Brooks County High School Field House HVAC upgrades.

ADDENDUM NO. 1

ADDENDUM NO. 1

DATE: July 02, 2025
Project: Falfurrias HS Fieldhouse HVAC Upgrades
Project #: 25v50
To: David Monreal, GMS

ME3.1

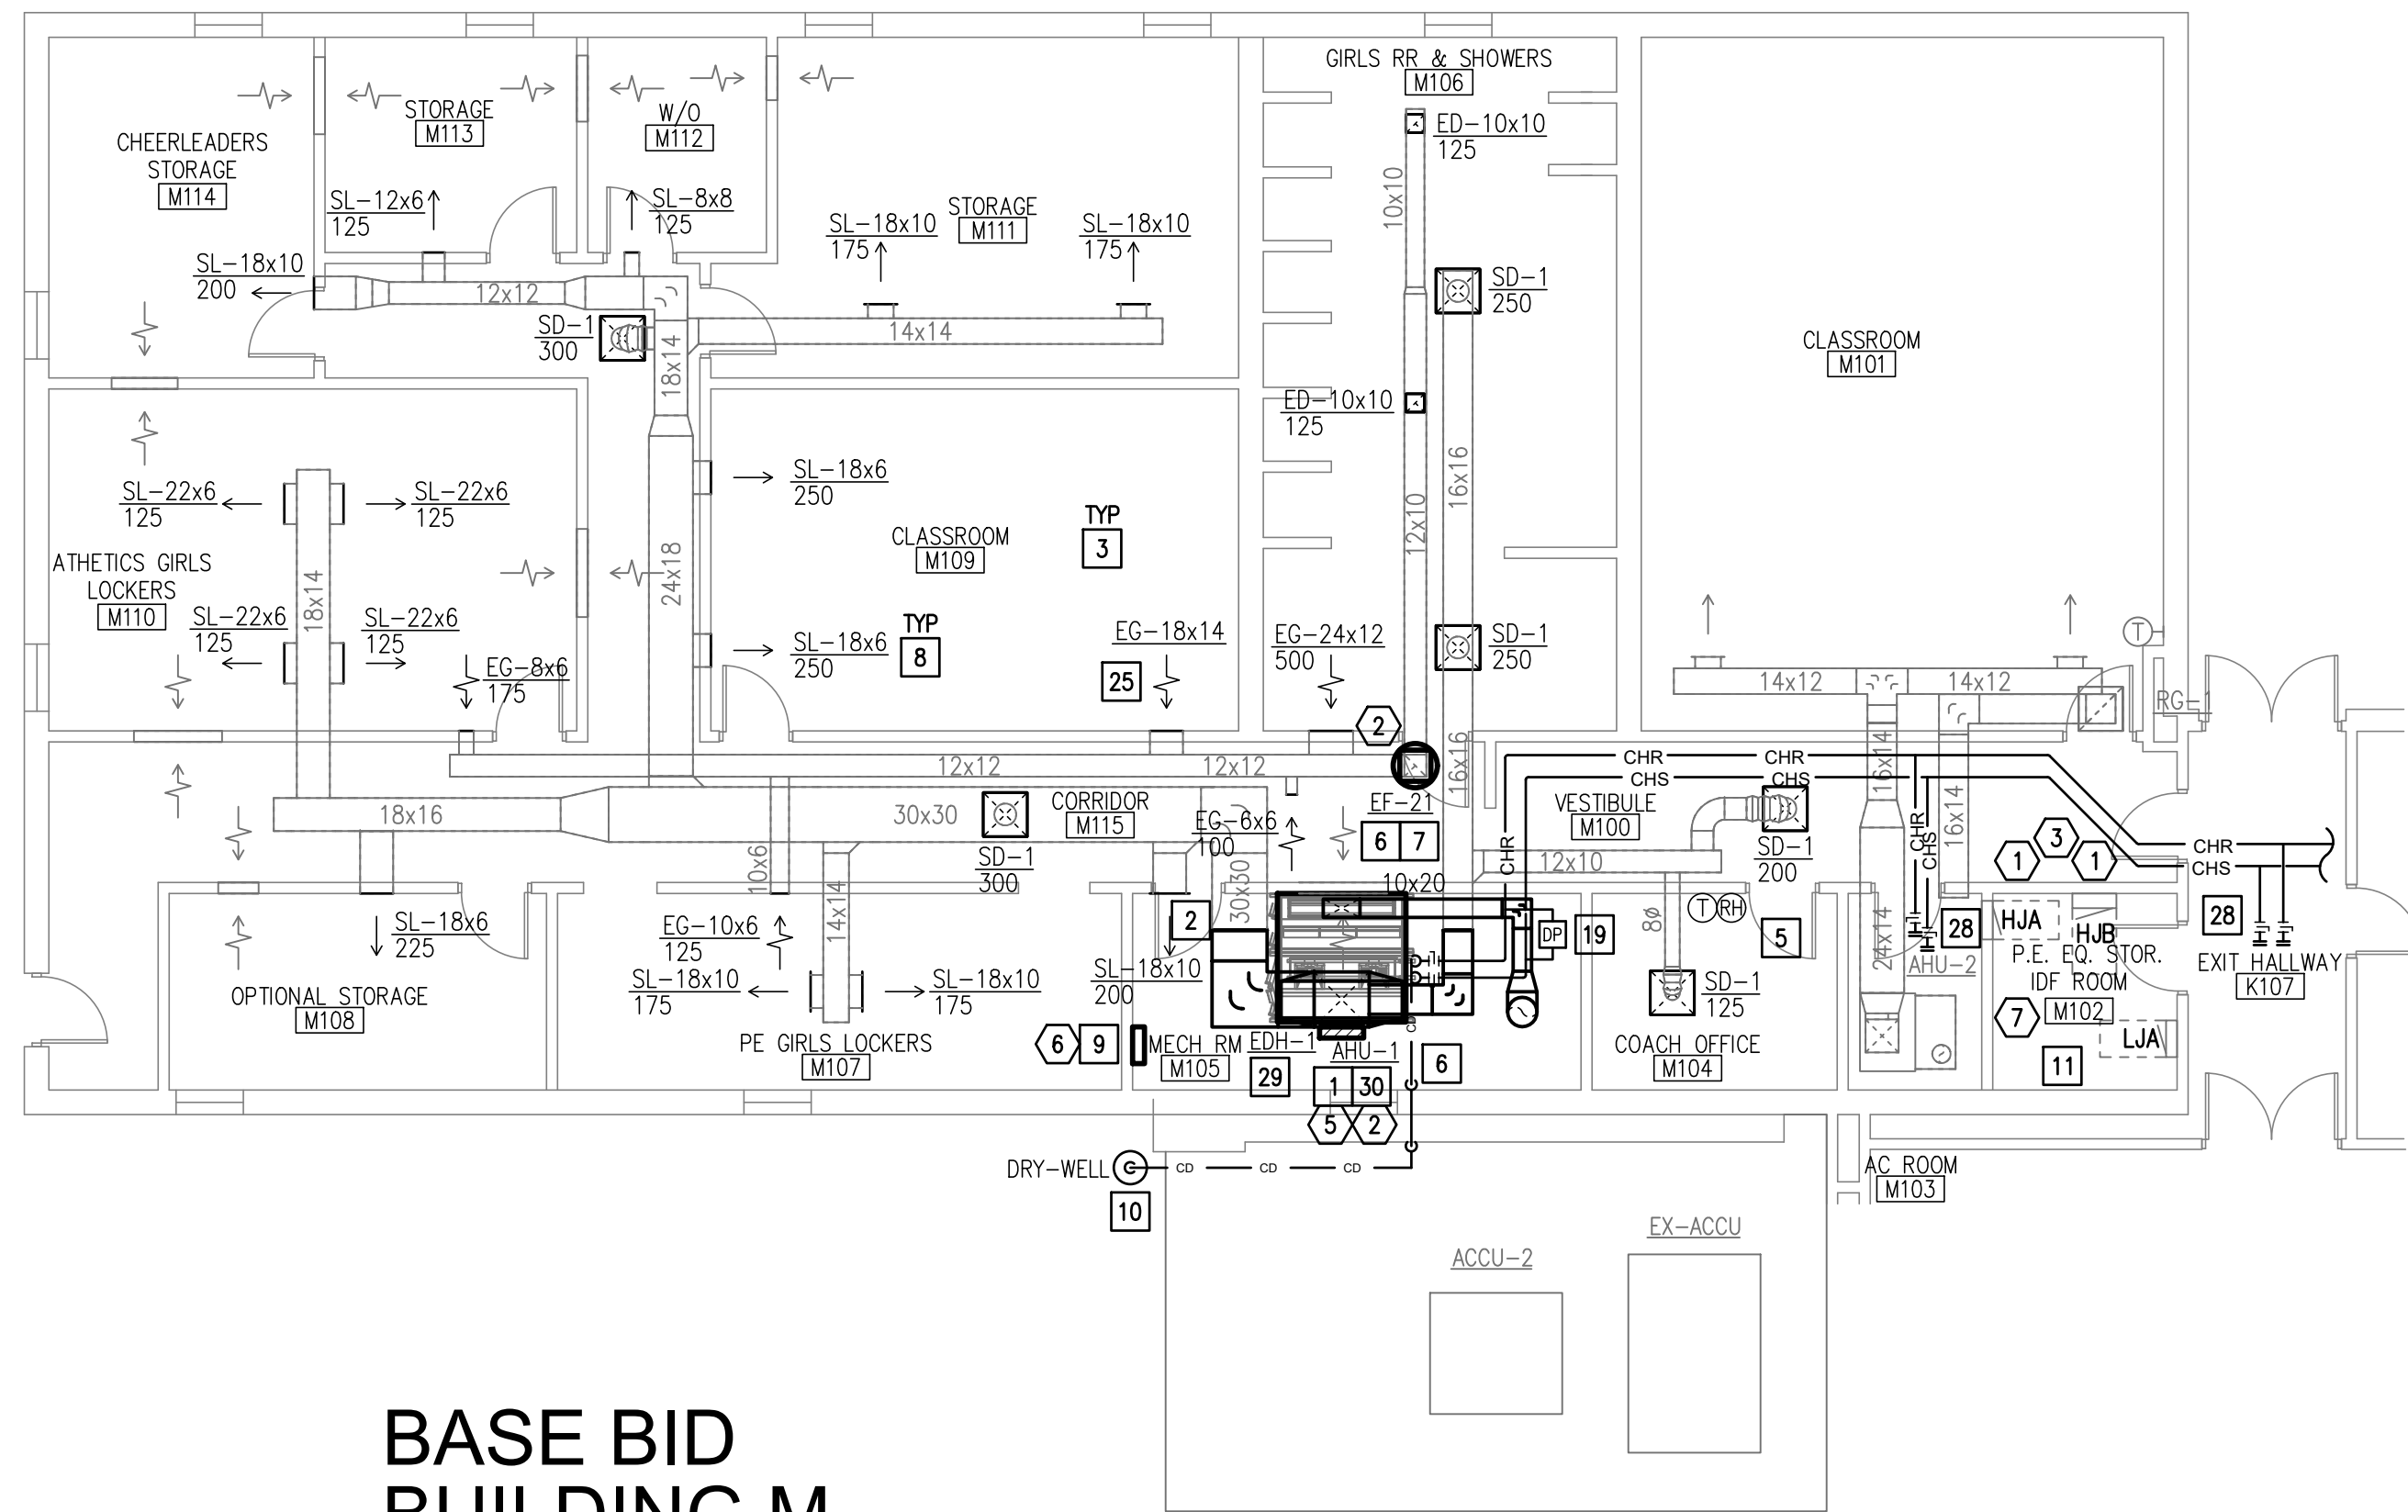
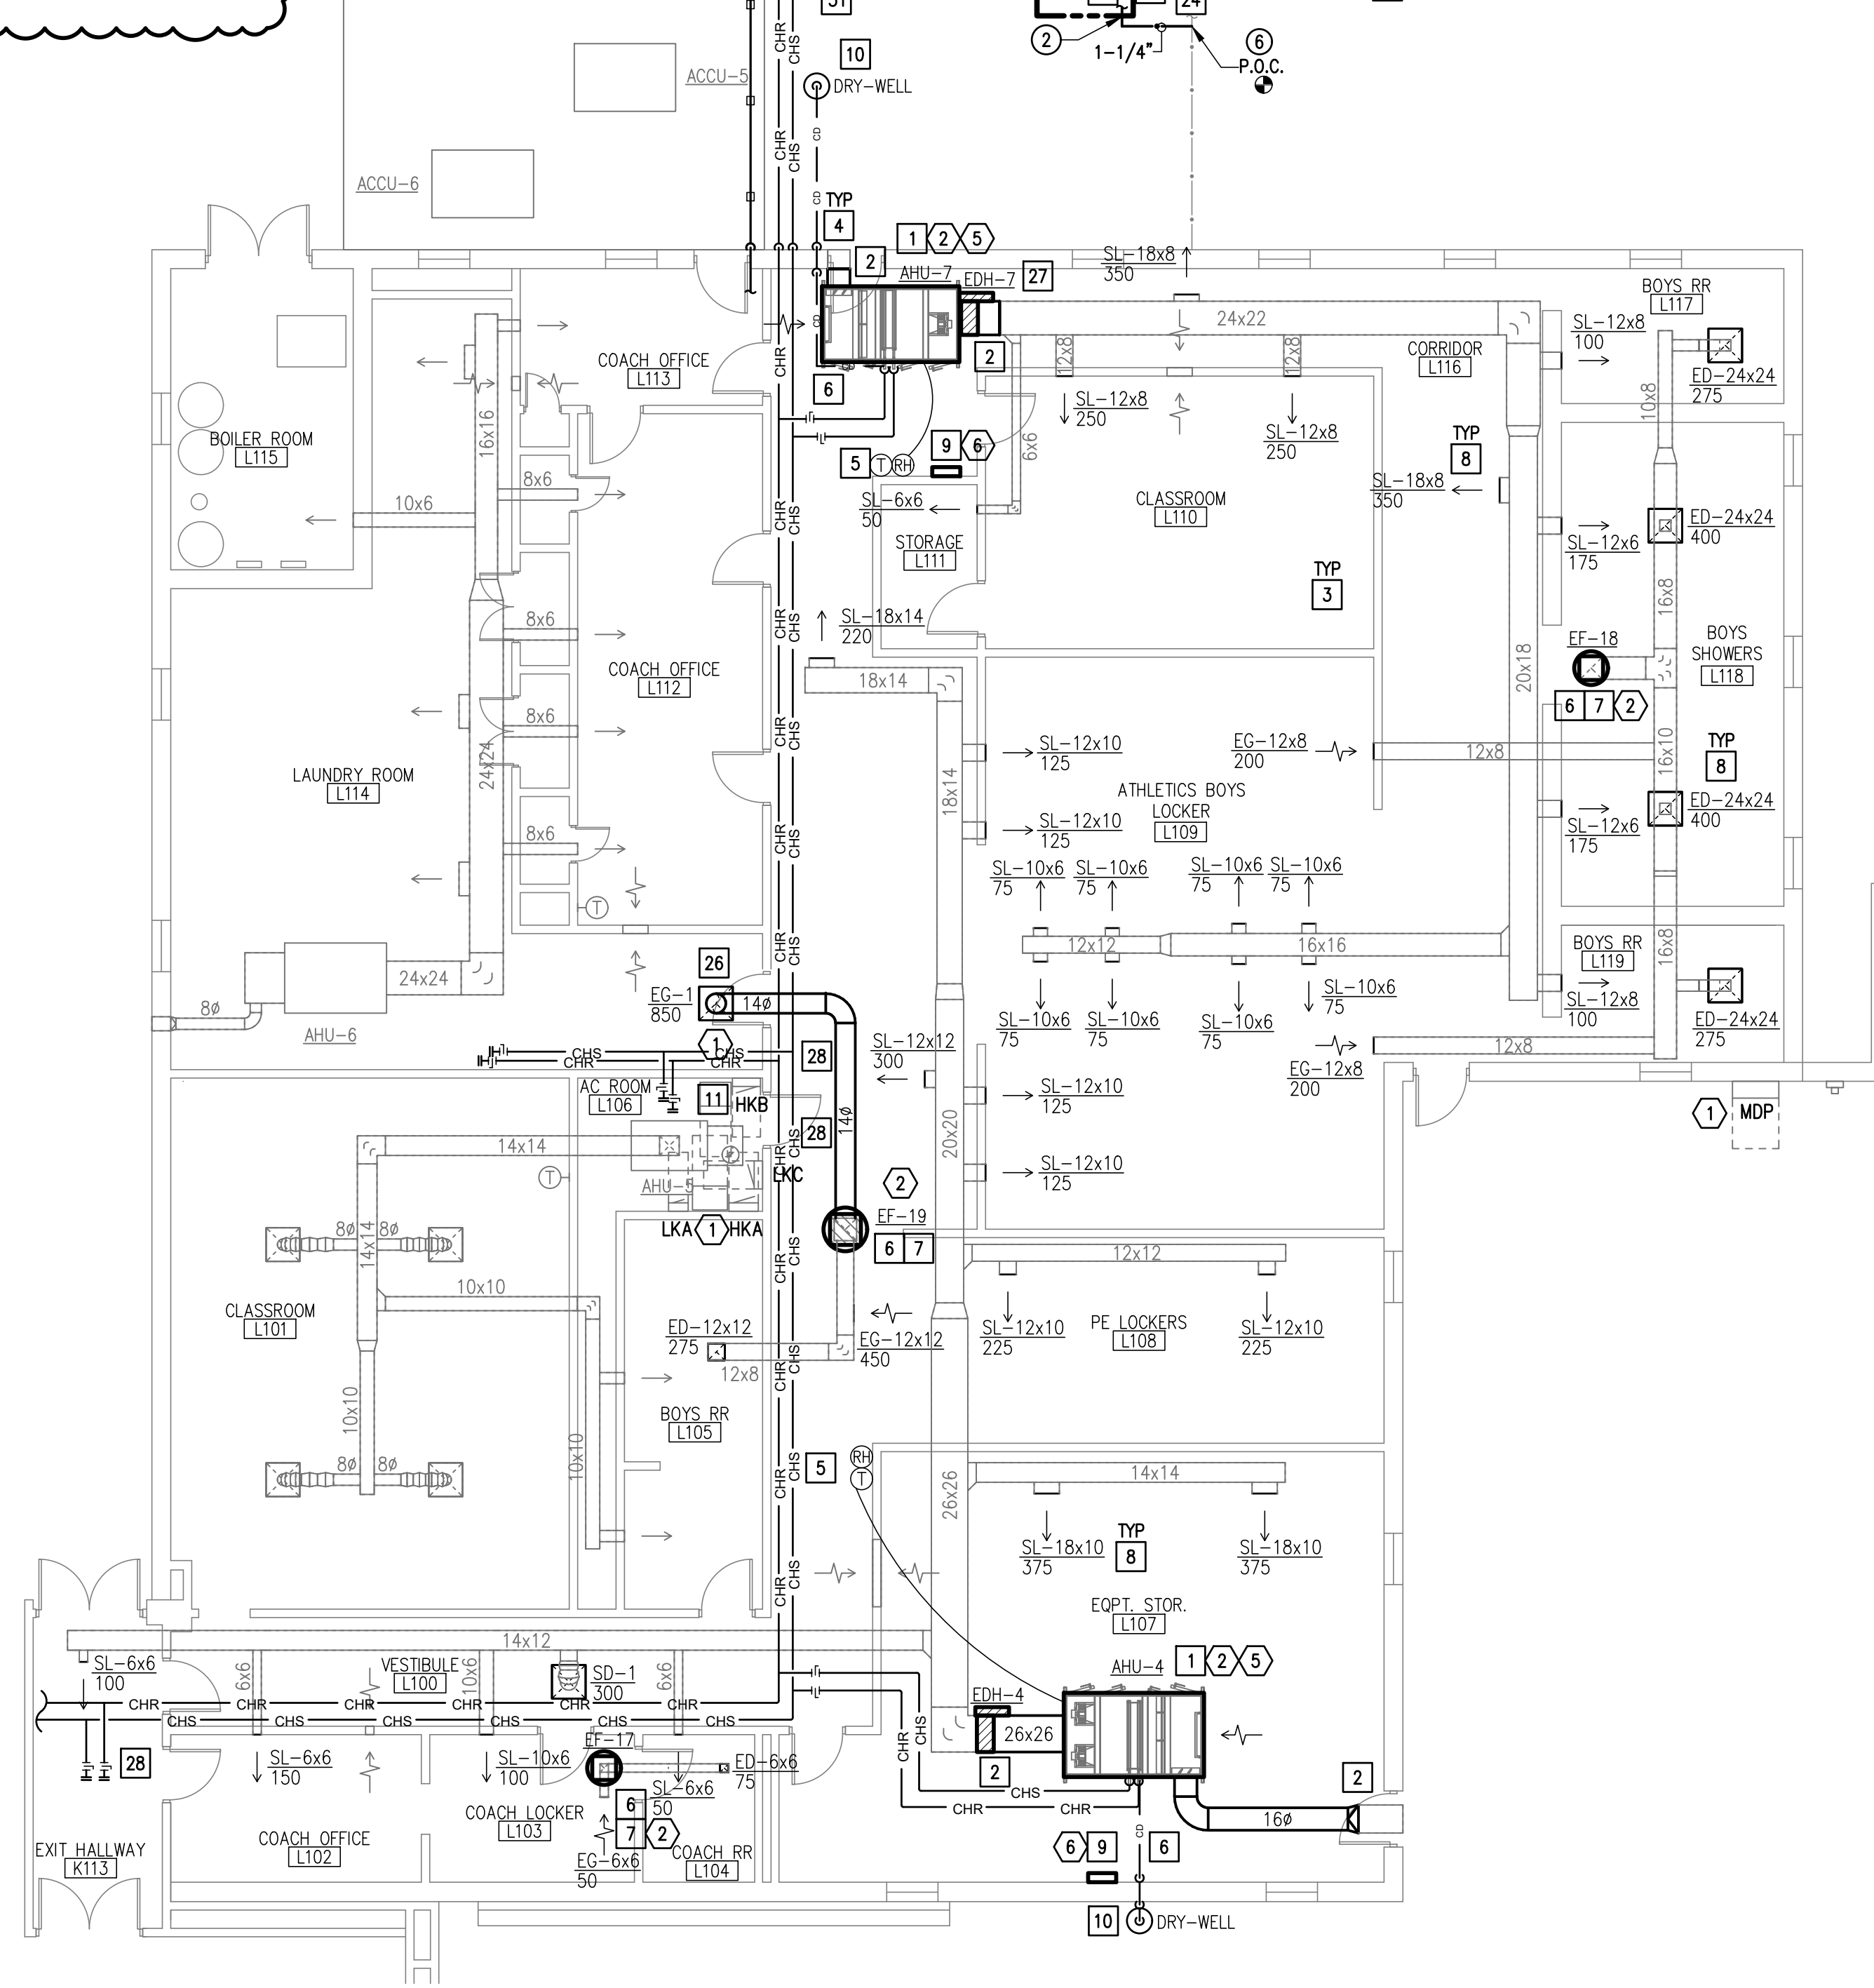
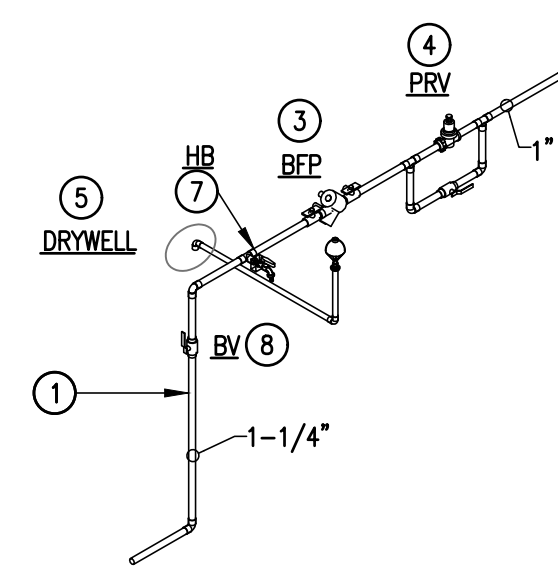
5. Sheet ME3.1:
 - a. Revised Building M and Building L Mechanical and Electrical renovation floor plan. See attached sheet.
6. Sheet ME3.2:
 - a. Revised Building M and Building L Mechanical and Electrical renovation floor plan. See attached sheet.
7. Sheet ME3.3:
 - a. Revised Building M and Building L Mechanical renovation roof plan. See attached sheet.
8. Sheet ME4.0:
 - a. Revised Building L, M and Central Plant Chilled Water Schematic Diagram. See attached sheet.
9. Sheet ME5.0:
 - a. Revised Mechanical and Electrical equipment and connection schedules. See attached sheet.
